AGENDA
COMMITTEE OF THE WHOLE
March 27, 2018
2200 Harnish Drive
Village Board Room
- AGENDA -
7:30 P.M.

SUBJECT: **Case No. 2017-06. River Bluff Estates – Final Plat and Final PUD**

**VILLAGE OF ALGONQUIN
PLANNING AND ZONING COMMISSION
Meeting Minutes
William J. Ganek Municipal Center-Board Room
August 14, 2017
7:30 p.m.**

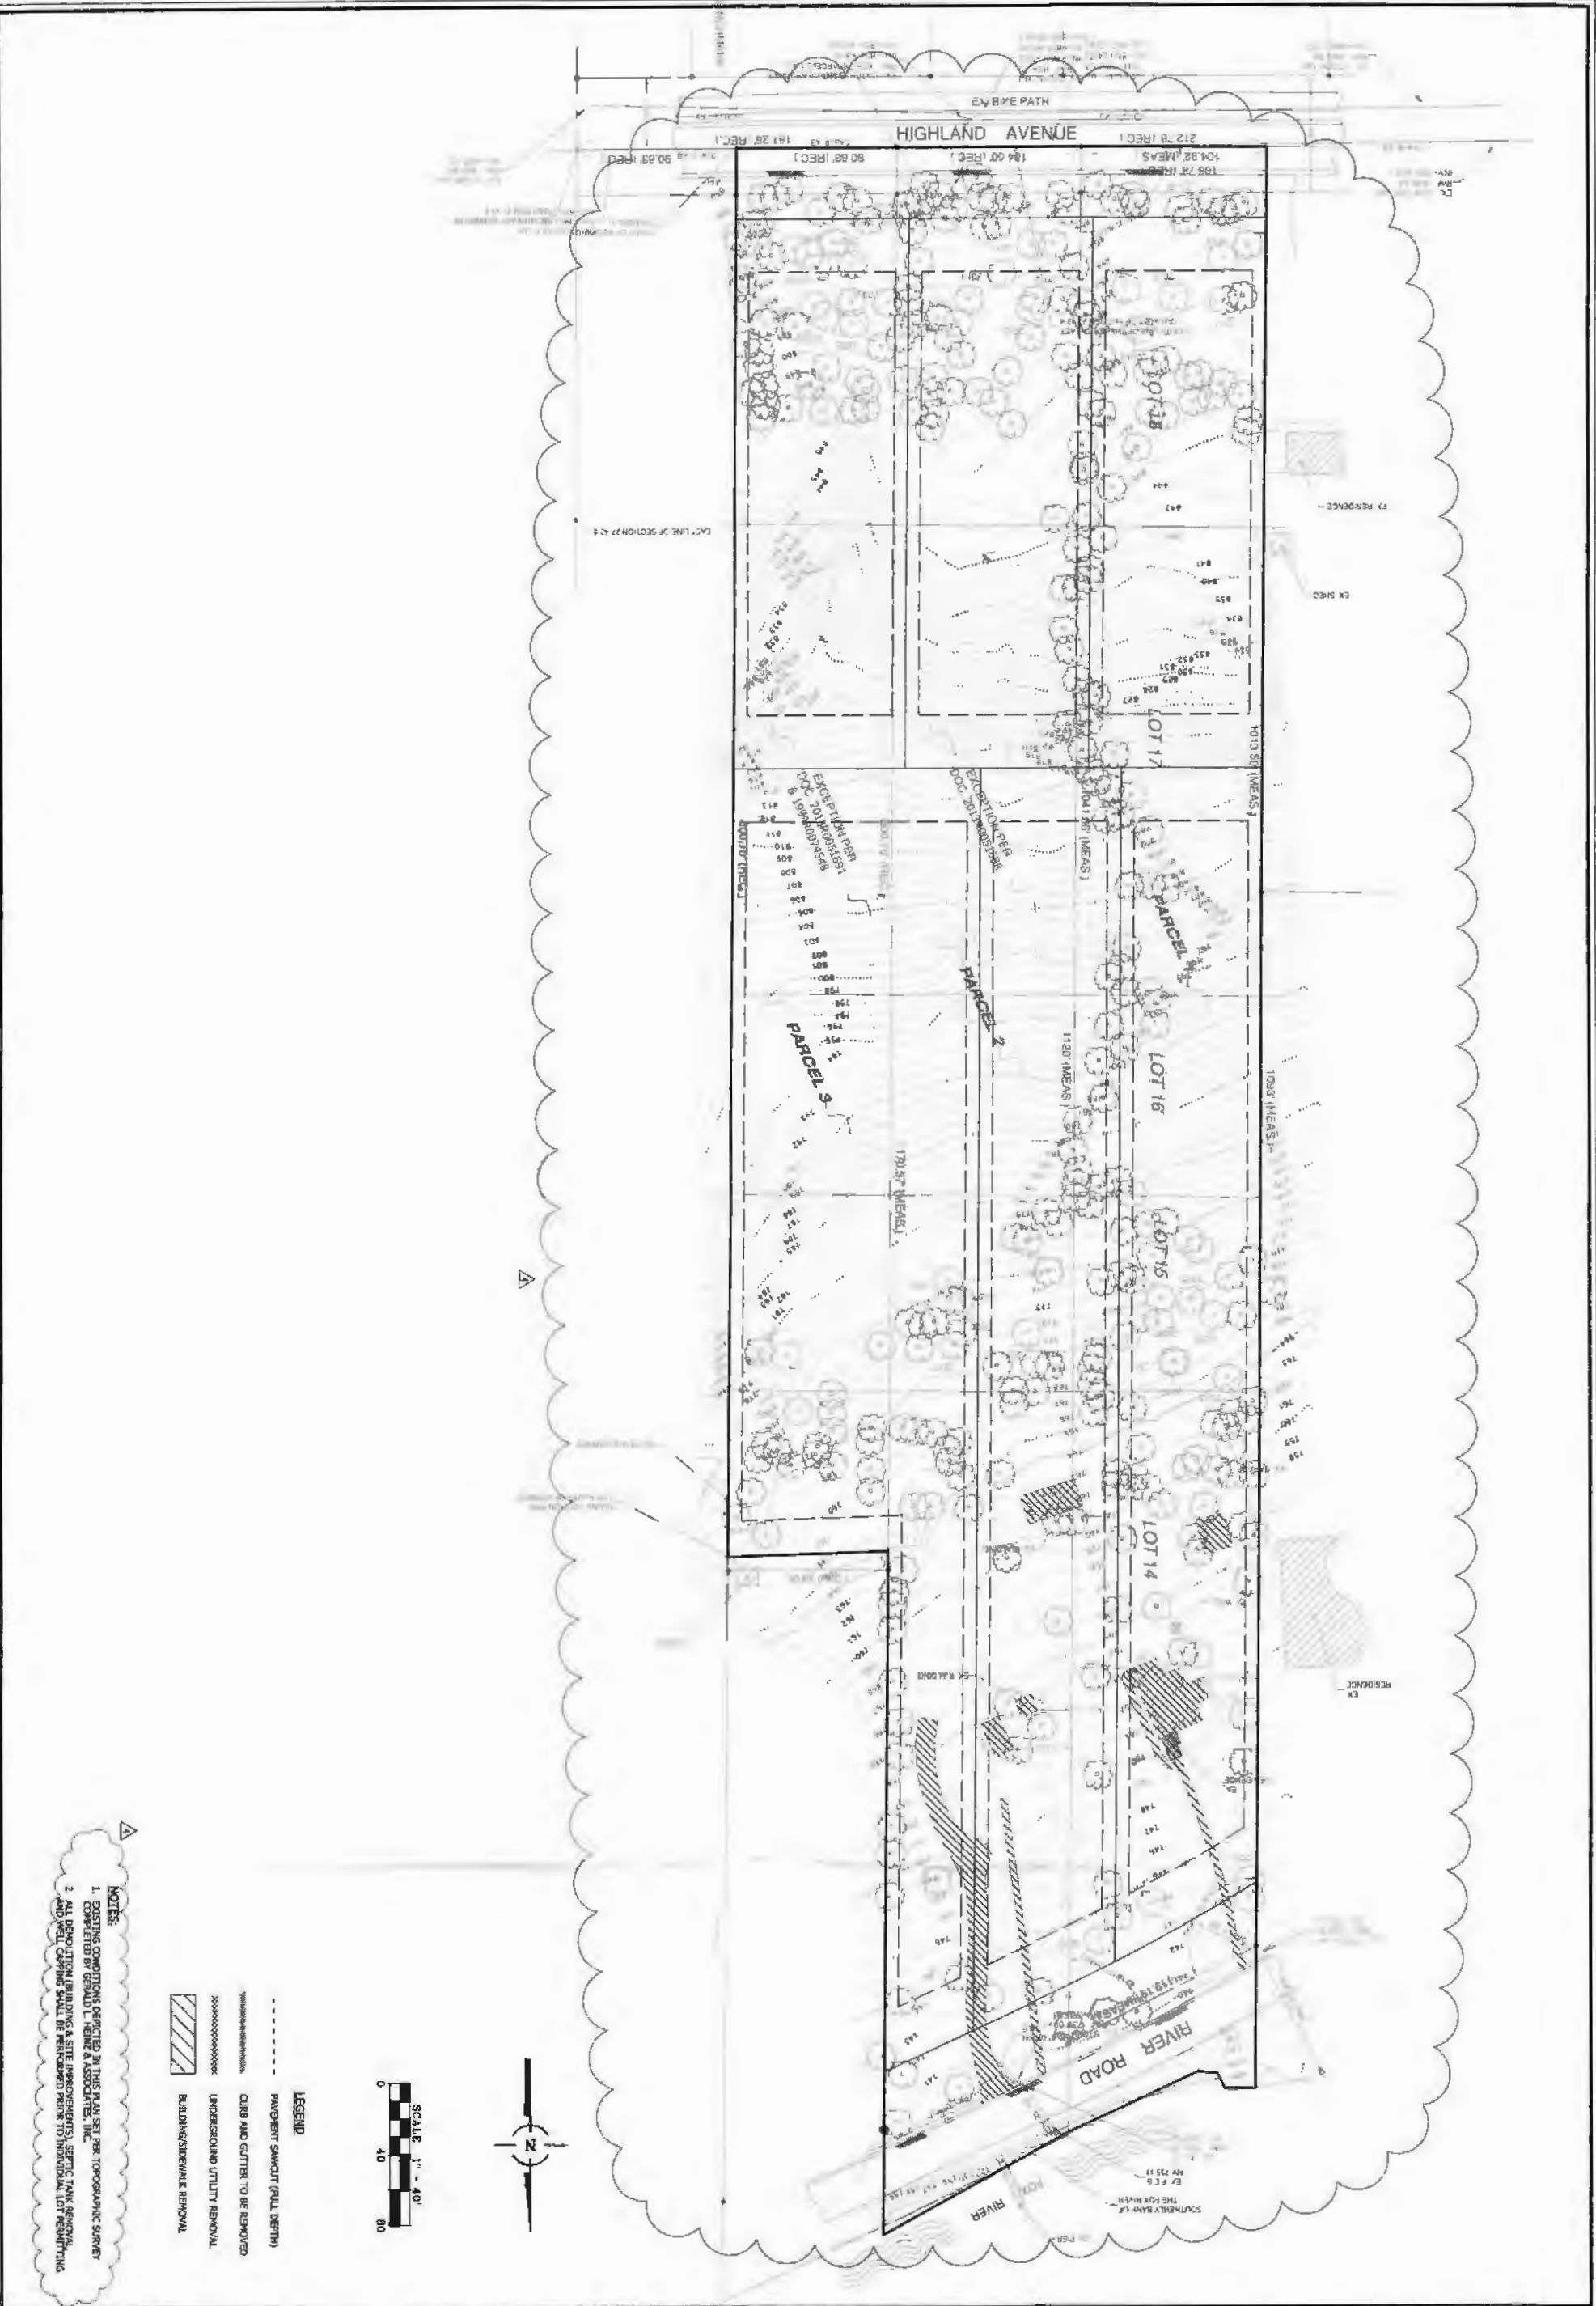
Parcel #3 exceeds the 300' requirement from a fire hydrant which needs to be addressed.

SHEET
GRUT2

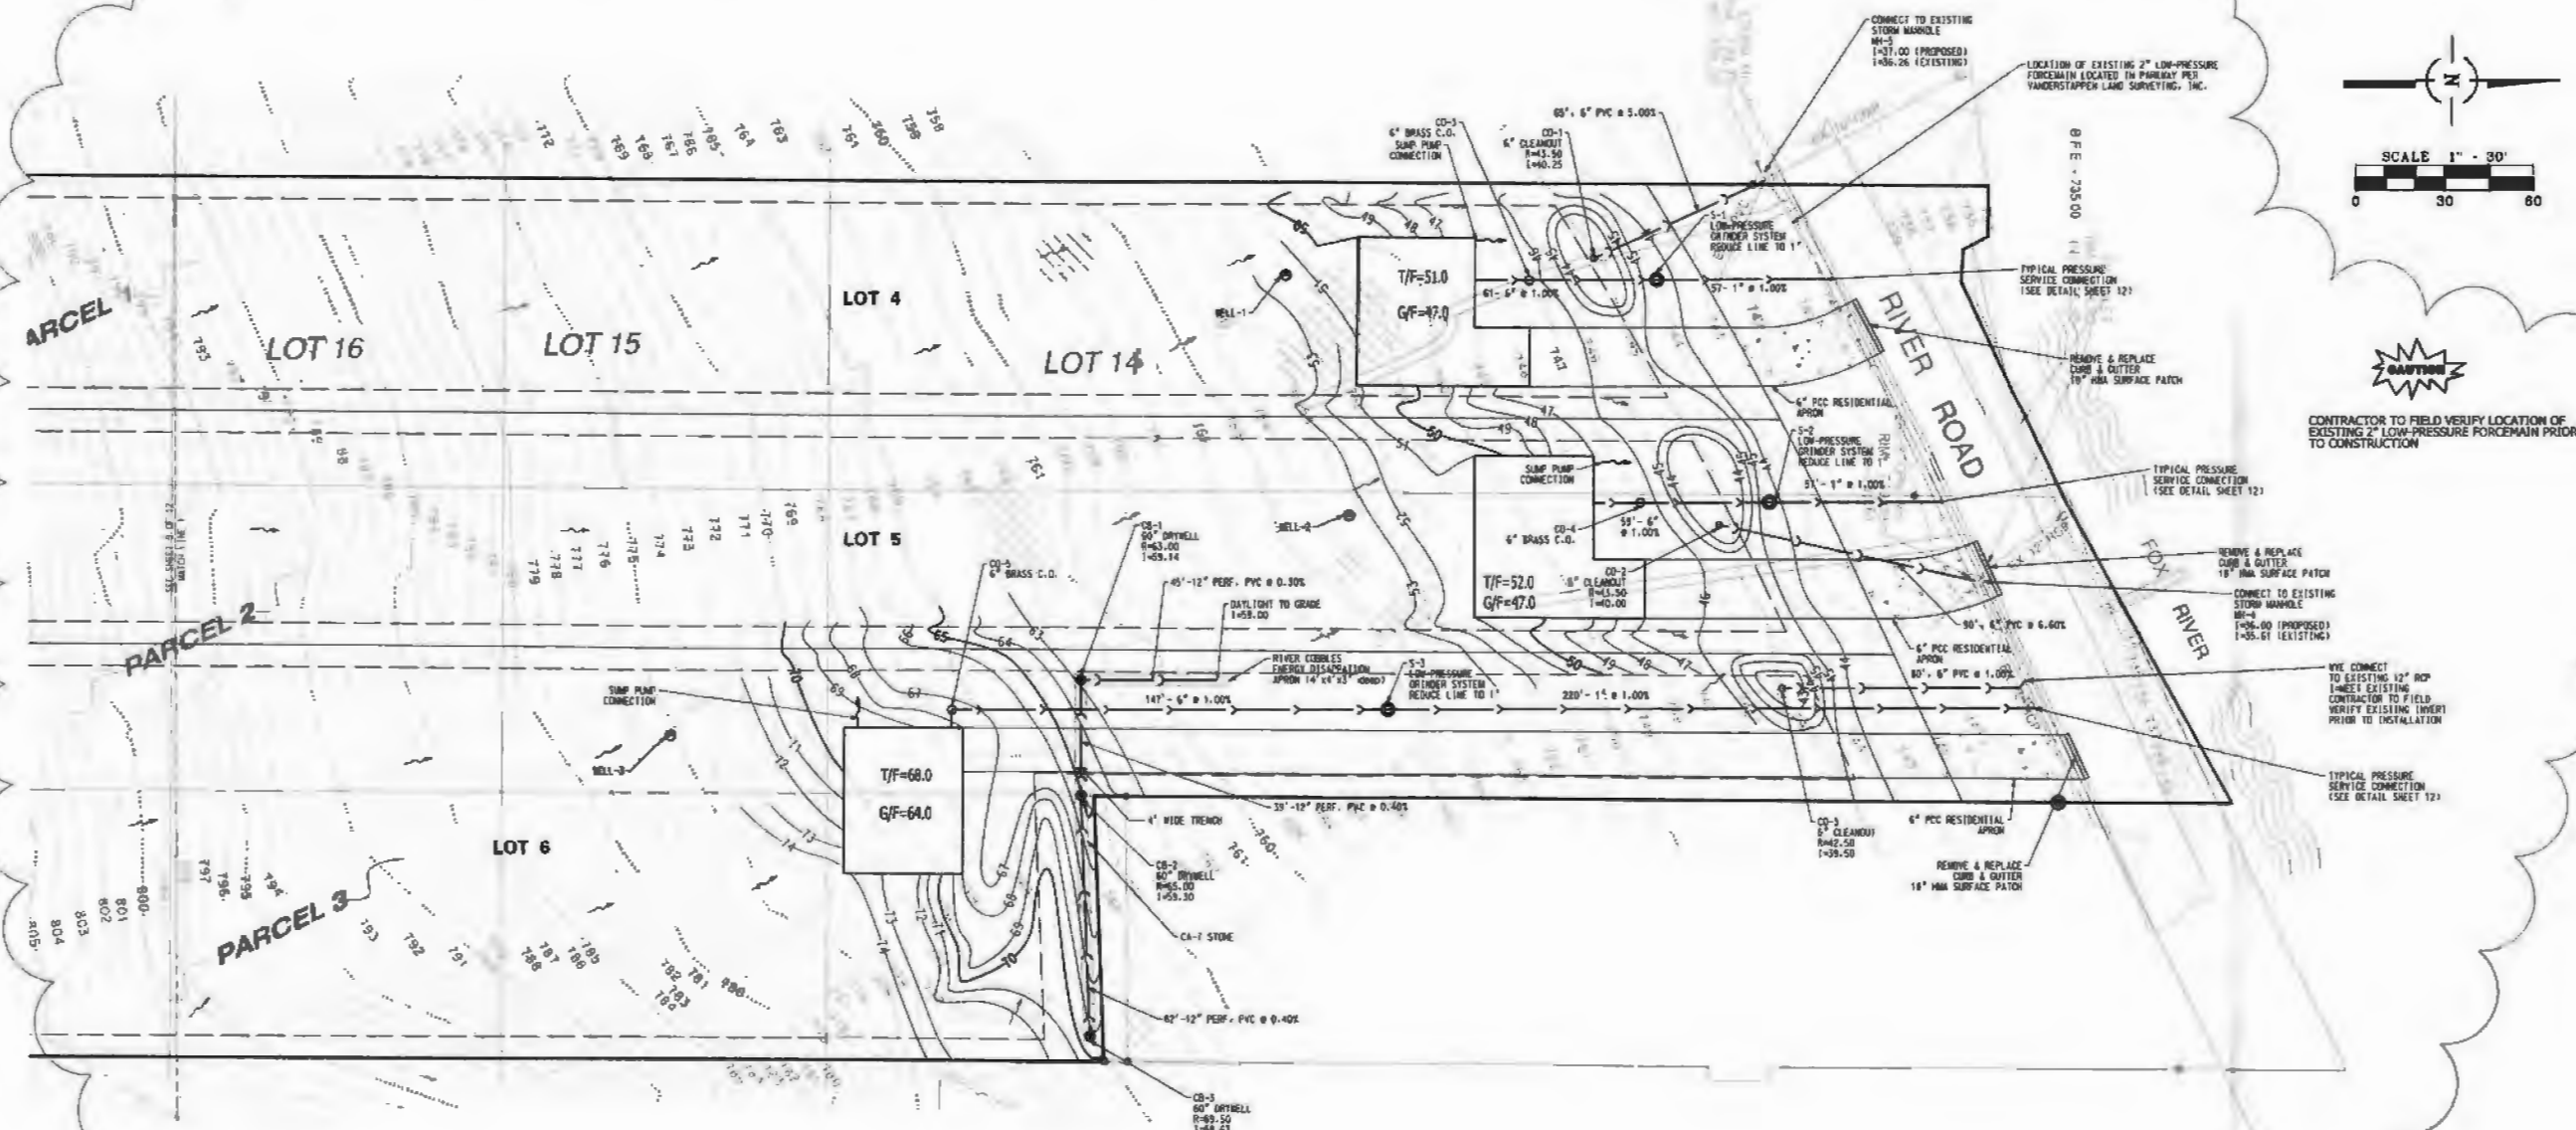
1. The newly added impervious surface table needs to be corrected to reflect that the 0.52 acres of allowable impervious surface is to be spread over all six (6) lots and not just the three (3) listed in the table. The attached exhibit from the engineer details the original detention calculations and how the value of 0.52 acres was derived.

2. The newly added impervious surface table needs to be corrected to reflect that the 0.52 acres of allowable impervious surface is to be spread over all six (6) lots and not just the three (3) listed in the table. The attached exhibit from the engineer details the original detention calculations and how the value of 0.52 acres was derived.
